**ZONING CHANGE REVIEW SHEET****CASE:** C814-2017-0001 – 425 W. Riverside PUD**Planning Commission Date:** February 13, 2018**ADDRESS:** 425 W. Riverside Drive**OWNER/APPLICANT:** Ronald A. Nelson and Molly Belle Properties (Ronald Nelson, Trustee)**AGENT:** Armbrust & Brown (Richard Suttle)/Stream Realty (David Blackbird)**ZONING FROM:** CS-1-V-NP      **TO:** PUD-NP**AREA:** 1.45 acres (63,162 sq. ft.)**SUMMARY STAFF RECOMMENDATION:**

Planning and Zoning staff recommends PUD zoning with conditions as referenced in the Land Use Plan.

425 WEST RIVERSIDE DRIVE  
AUSTIN, TRAVIS COUNTY, TEXAS  
EXHIBIT E - STREET CROSS-SECTIONS

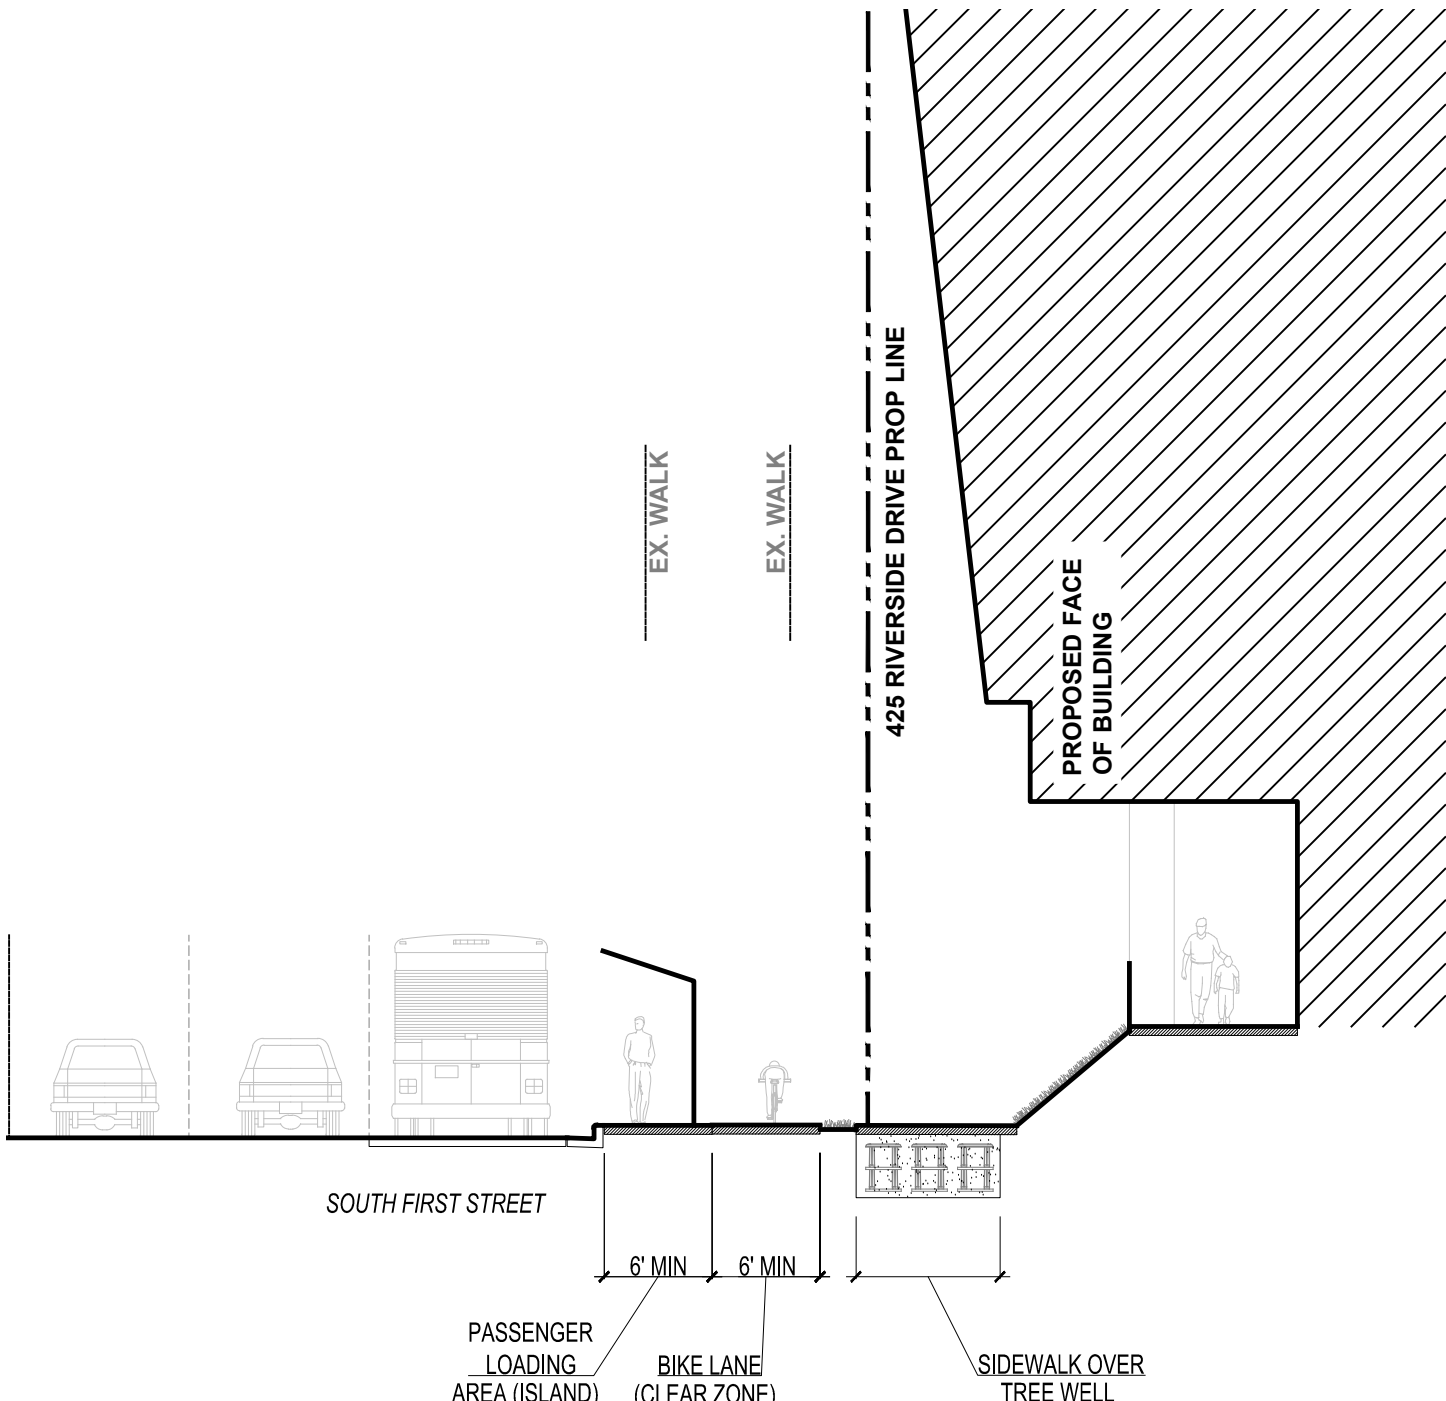
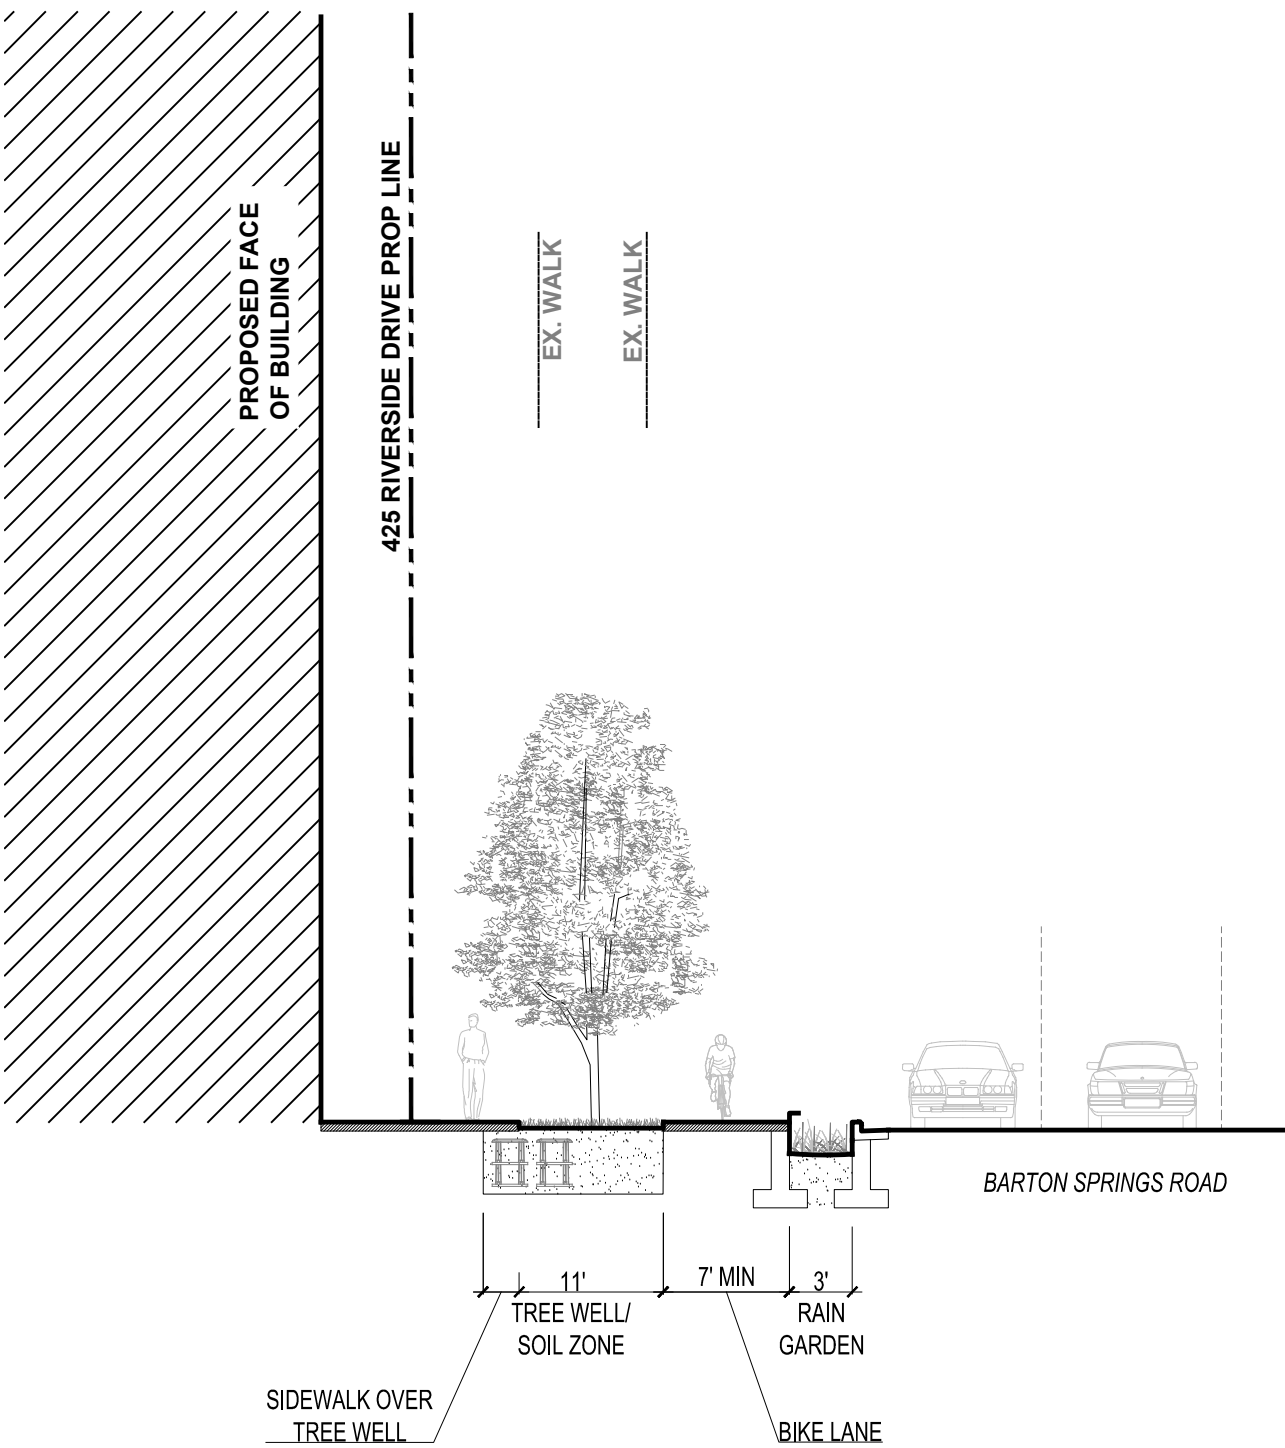
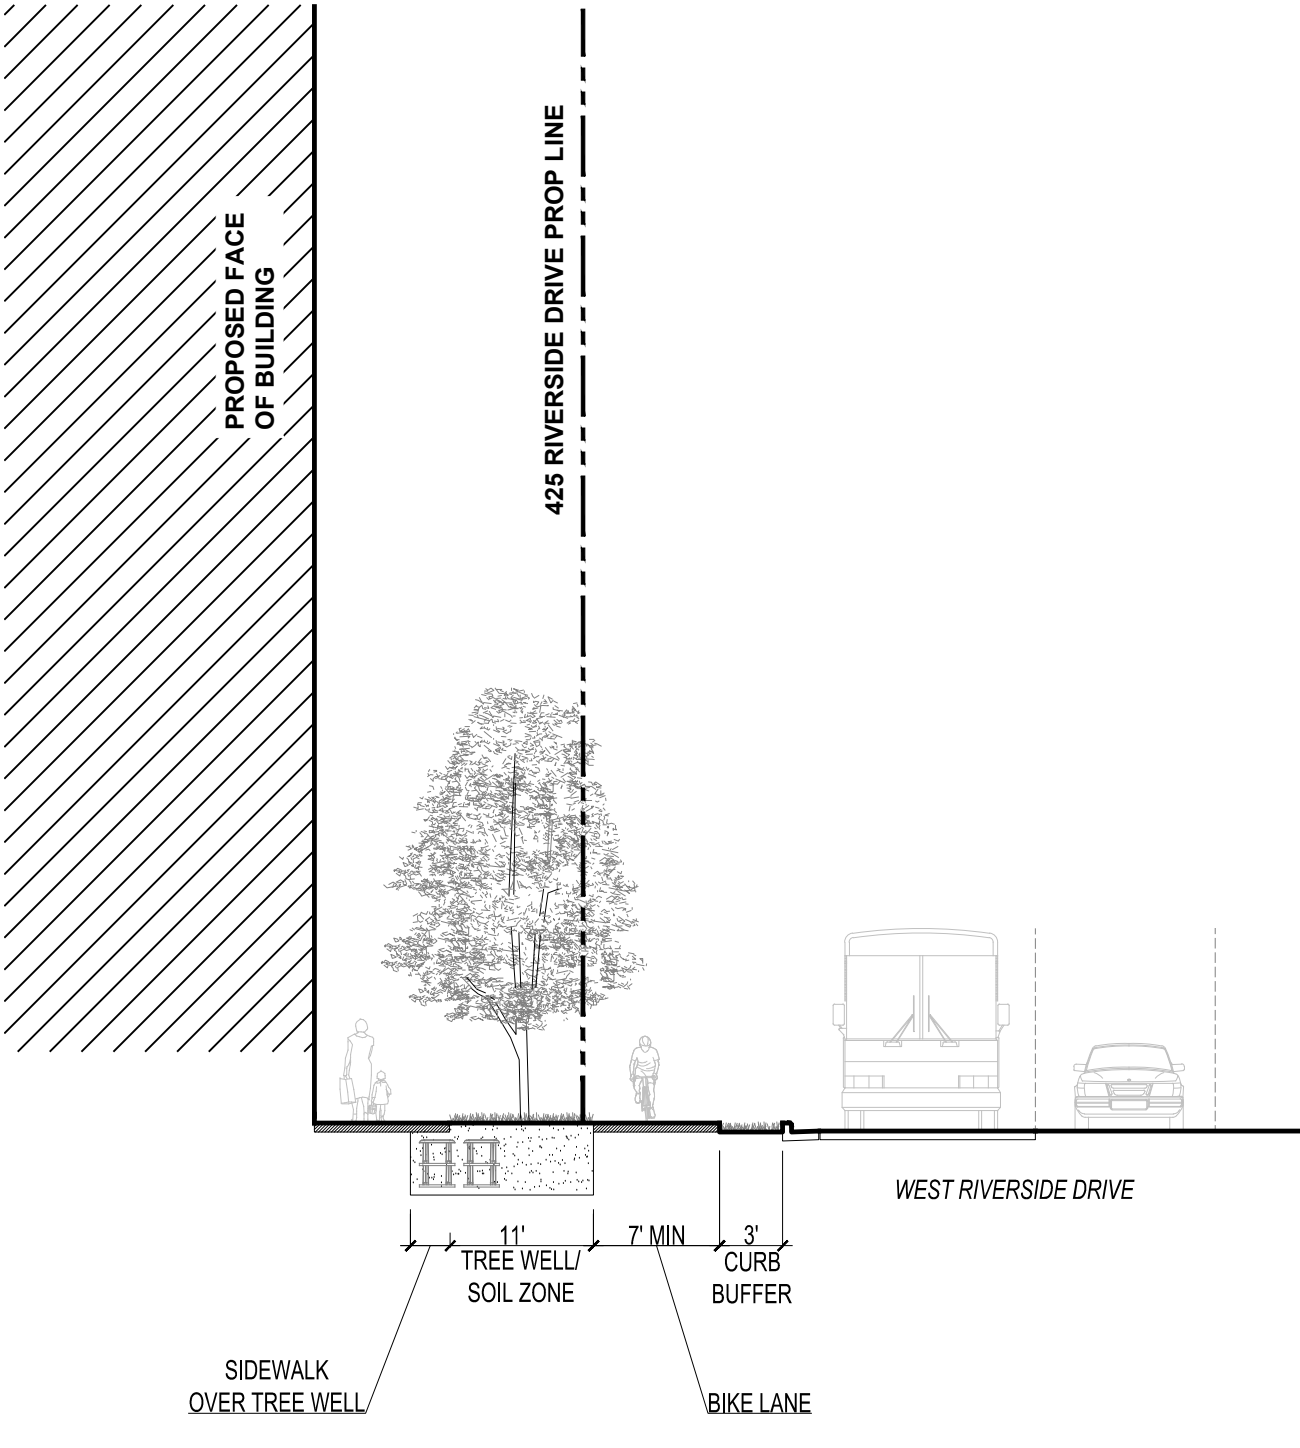
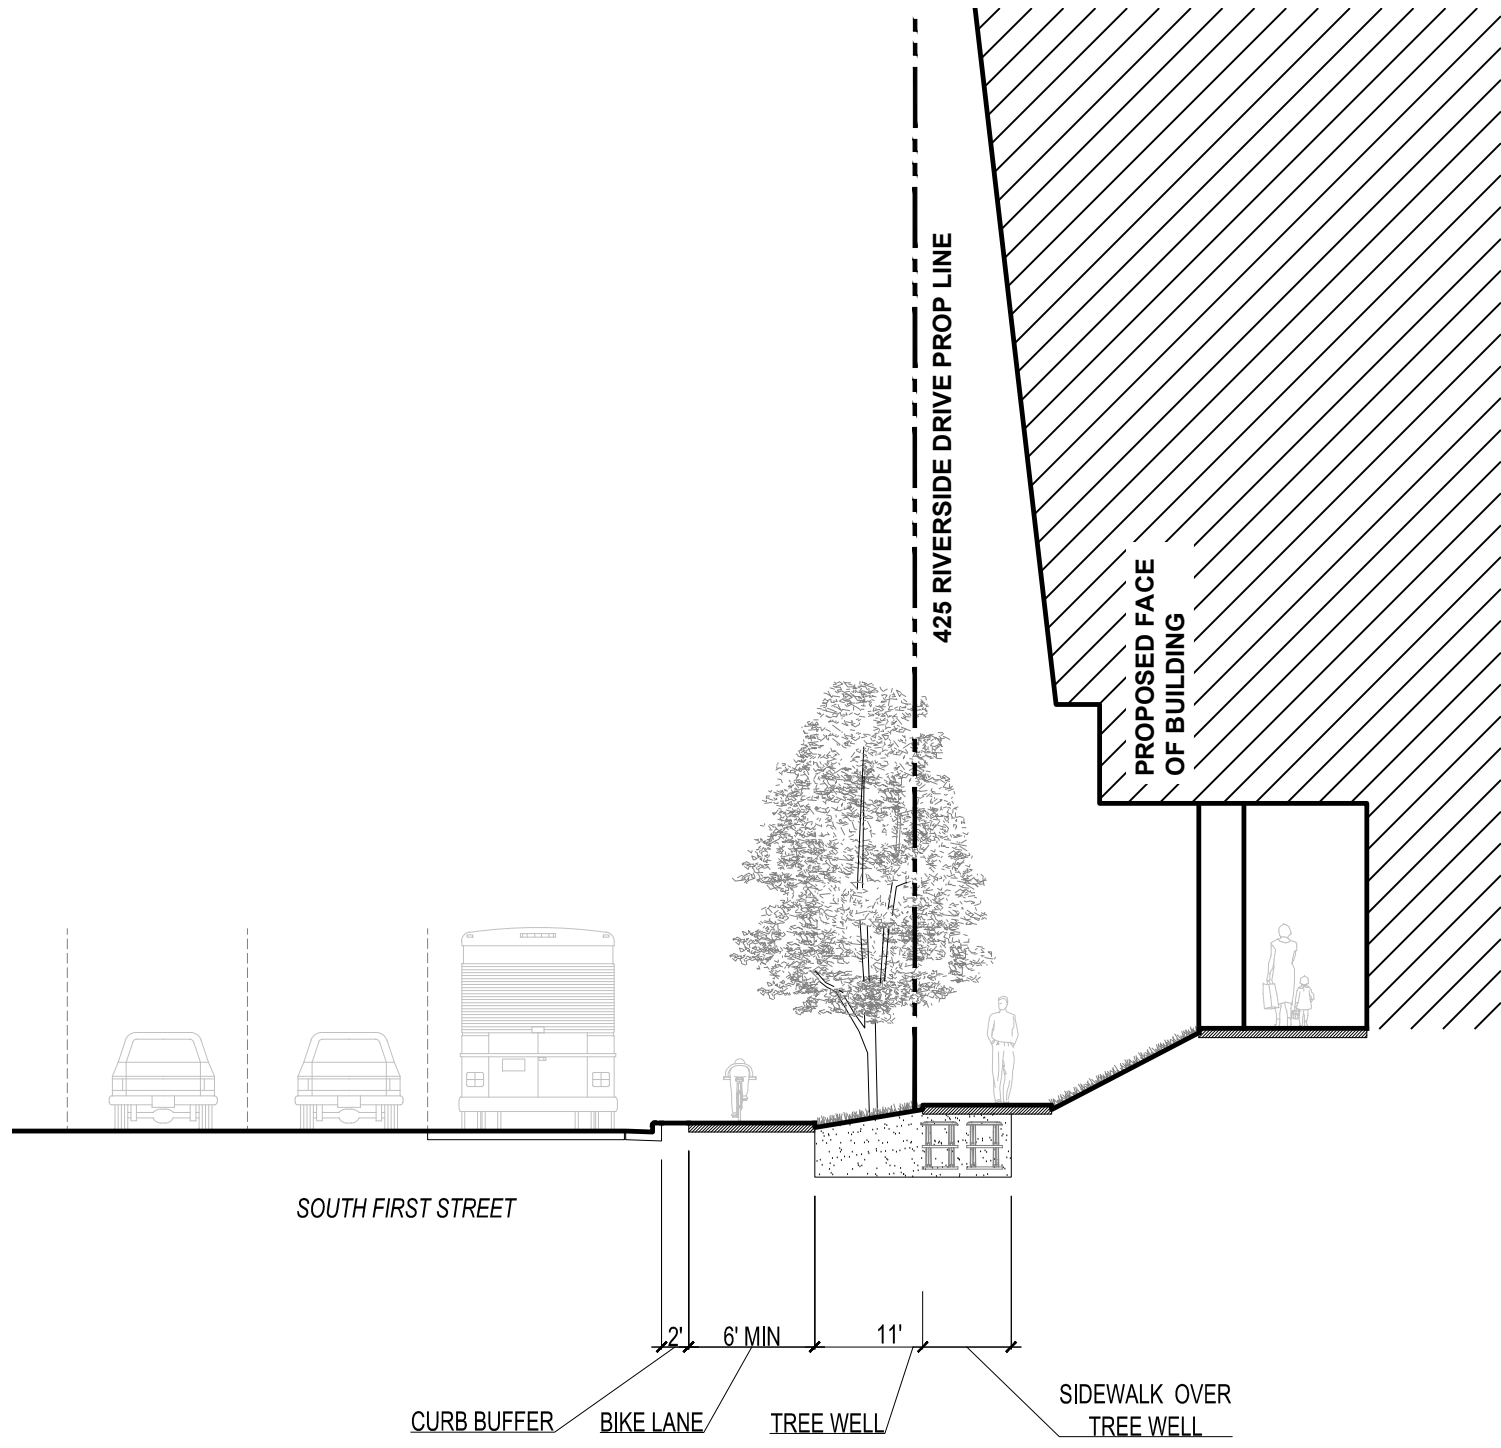
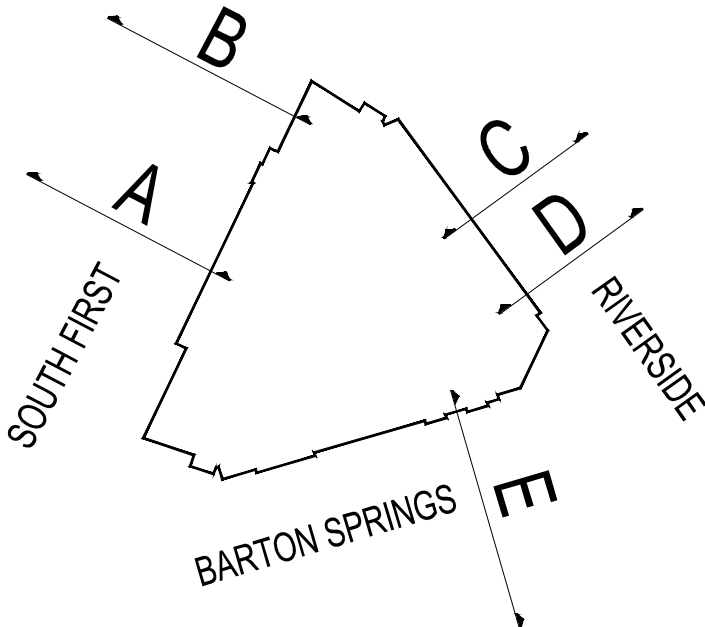
- #3 Bicycle Lane Width - the bicycle lane widths do not conform to the original drawing I sent in May. In the attached Exhibit C and E I have marked up width changes. In short the following are the dimensional requirements for the bicycle lane in a few scenarios:  
If pavement on either side of bicycle lane is not rideable than 7' is the minimum bikeway dimension.

If there is a dropoff into a rain garden there needs to be a hand rail that is recessed from the bike lane by 6" as to not encroach in the bicycle lane space (handrails should be added to relevant cross sections in exhibit E. If there is rideable pavement on both sides of the bike lane the minimum acceptable dimension is 6'
